ADDENDUM #2 TO THE REQUEST FOR LETTER OF NO OBJECTION  
FOR  
**THE BRIDGES EAST**  
**SONOQUI CHANNEL MODIFICATIONS**

August 2012  
Project No. 1127

RE: Addendum #2 to the Request for Letter of No Objection for  
The Bridges East Sonoqui Channel Modifications  
HilgartWilson Project No: 1127.00

DWG. NO. **CD05**  
SHT. 5 OF 62

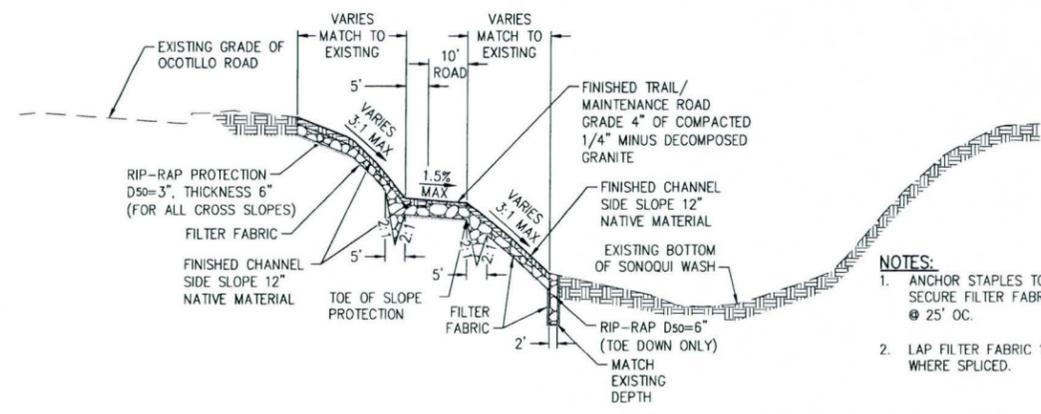
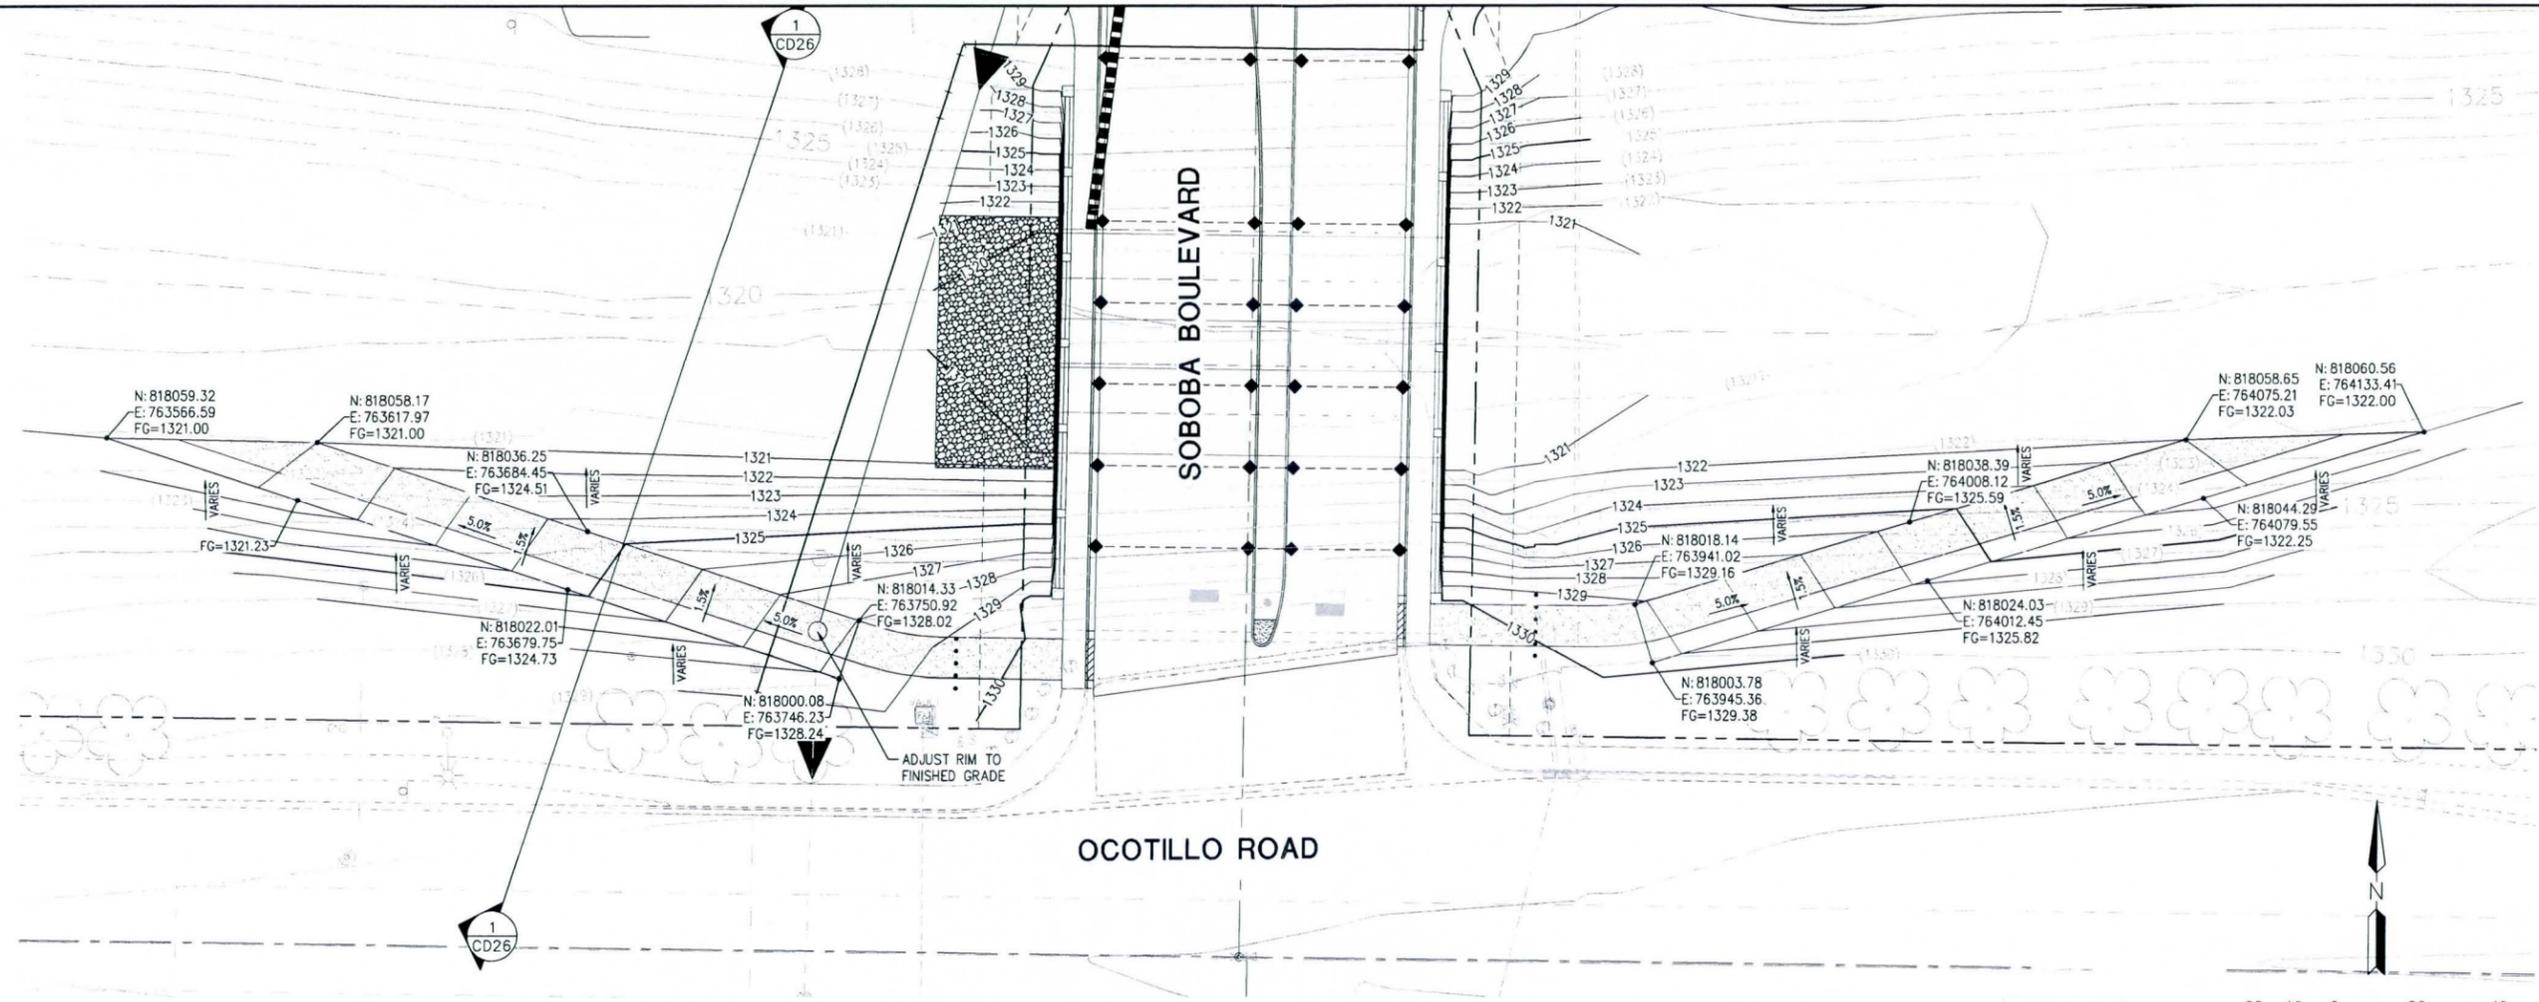
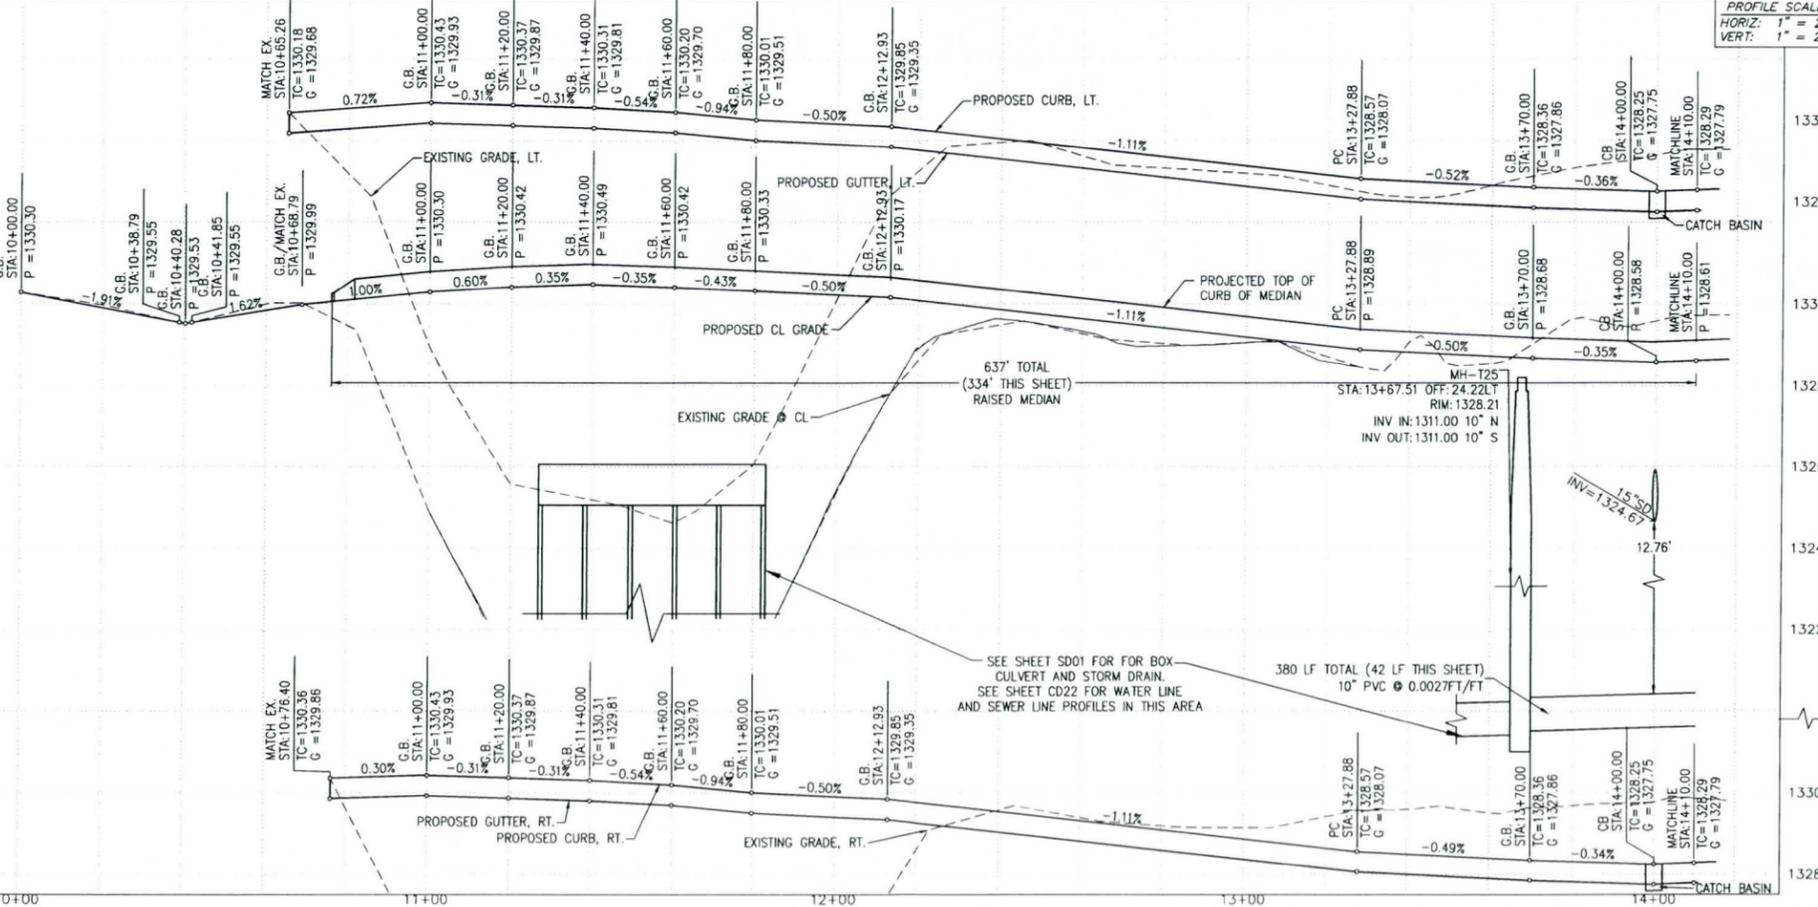
3. *Drawing CD05:*

- a. *Show maintenance access/multi-use path termination to either Ocotillo Rd or Soboba Street*

- b. *Provide appropriate curb treatment for vehicular access to maintenance path*

**Response:** The proposed east and west maintenance/multi-use ramps will both terminate to Soboba Street.

**Response:** Segments of 6-inch mountable curb will be placed at the Soboba Street frontage to the proposed east and west ramps.

LA3.2

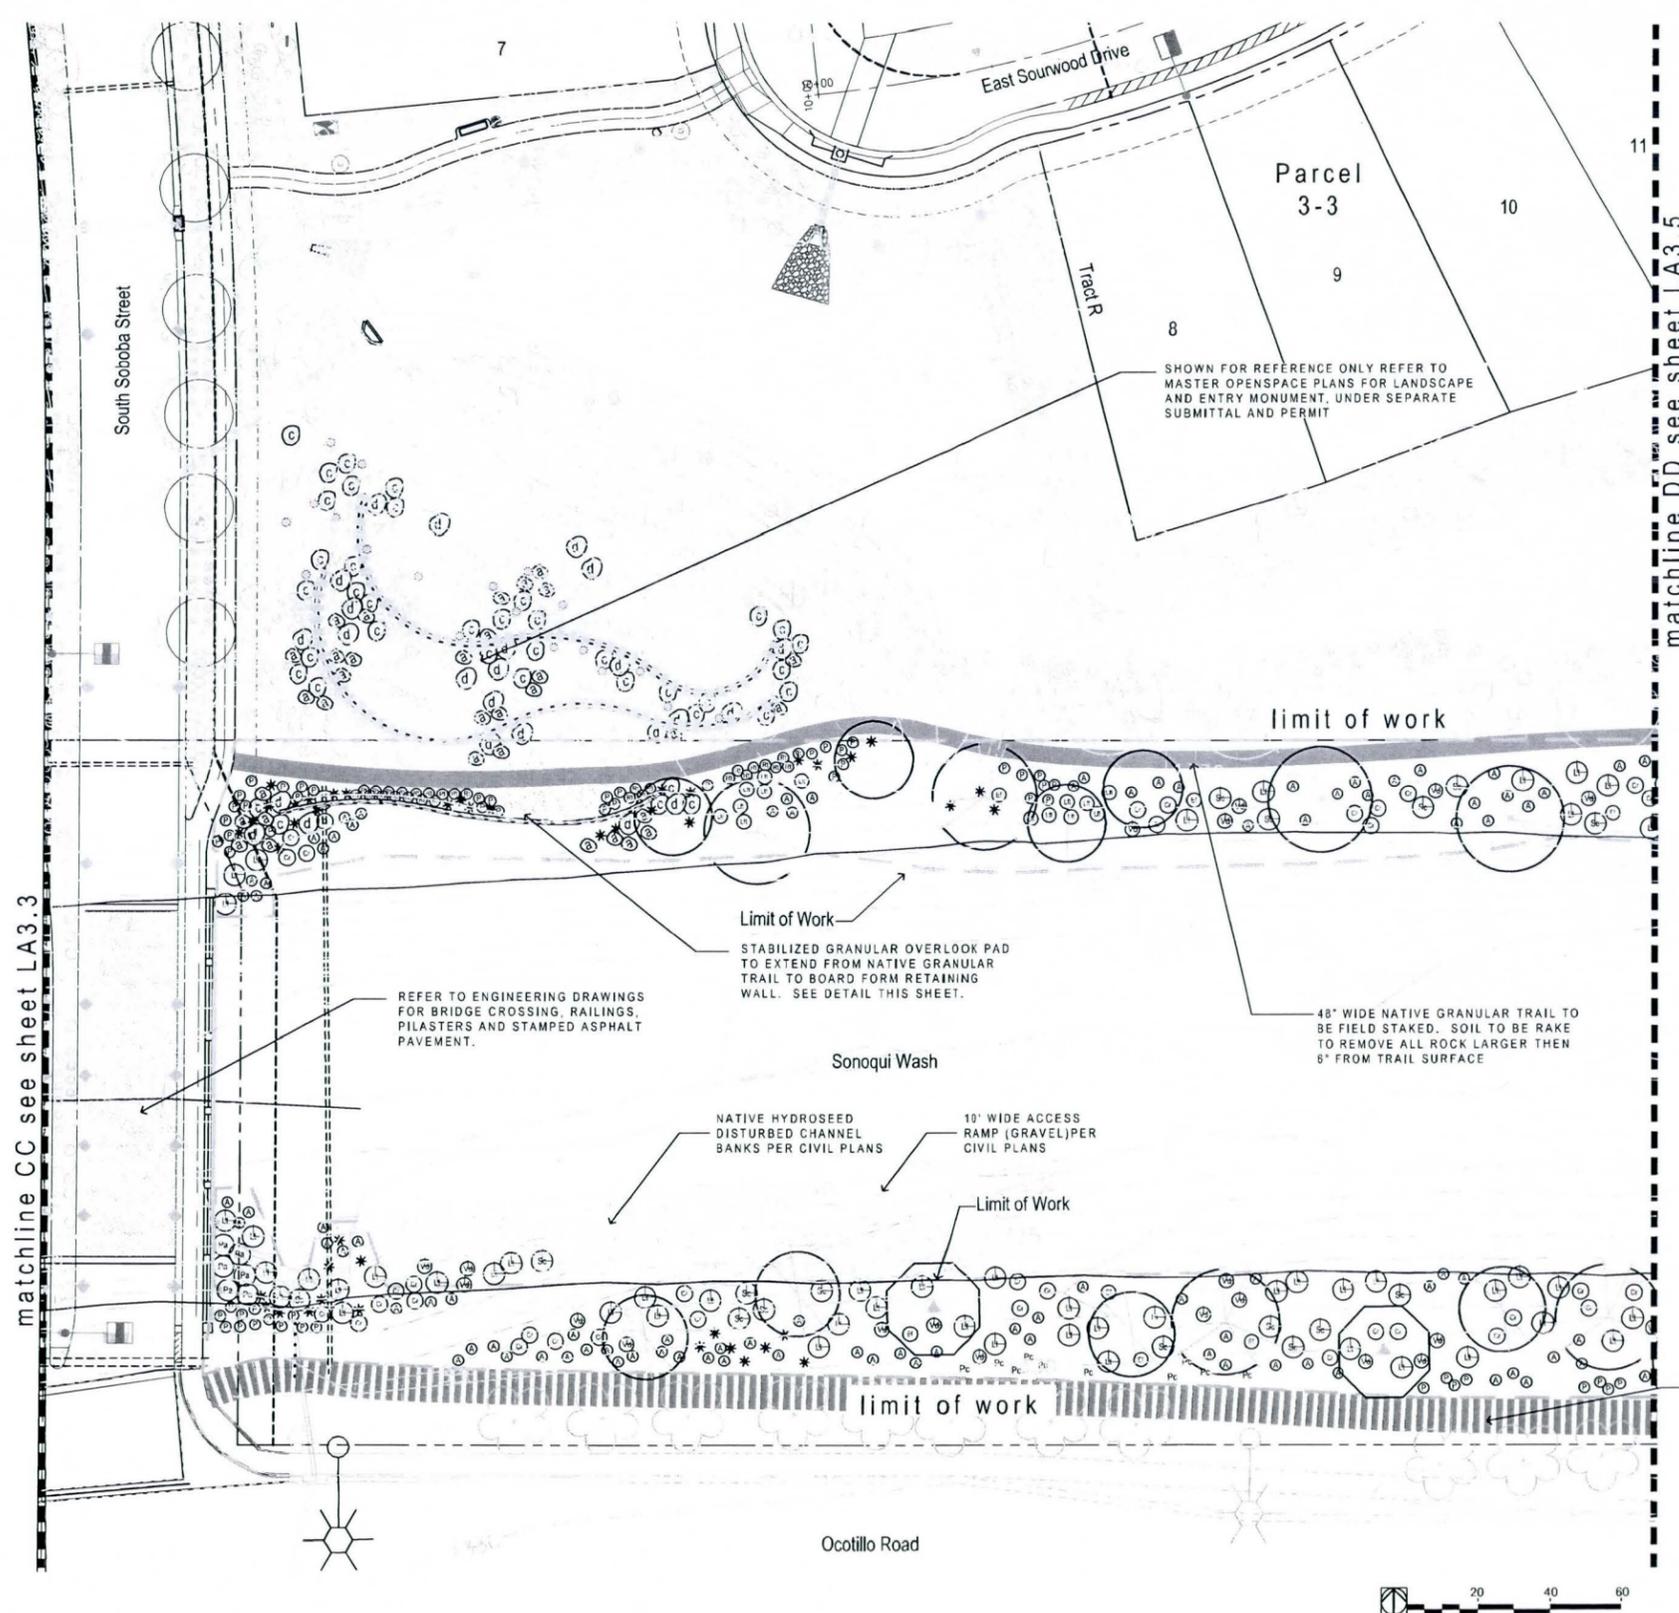
4. *Sheets LA3.3 & 3.4:*

- a. *Landscape plan is not coordinated with civil plans*

- b. *Show new ramps and treatment of disturbed channel surfaces shown on the grading plan, suggest hydroseeding the reconstructed slopes*

- c. *Where maintenance path connects to Ocotillo or Soboba, revise planting plan for appropriate treatment of path for maintenance vehicles to cross.*

**Response:** The Landscape Plans have been updated to match the Civil Improvement Plans.

**Response:** The Landscape Plans have been updated to reflect the proposed ramps and hydroseeding of the reconstructed slopes.

**Response:** The Planting Plan has been amended to provide an appropriate surface treatment for vehicular access to the ramps from Soboba.
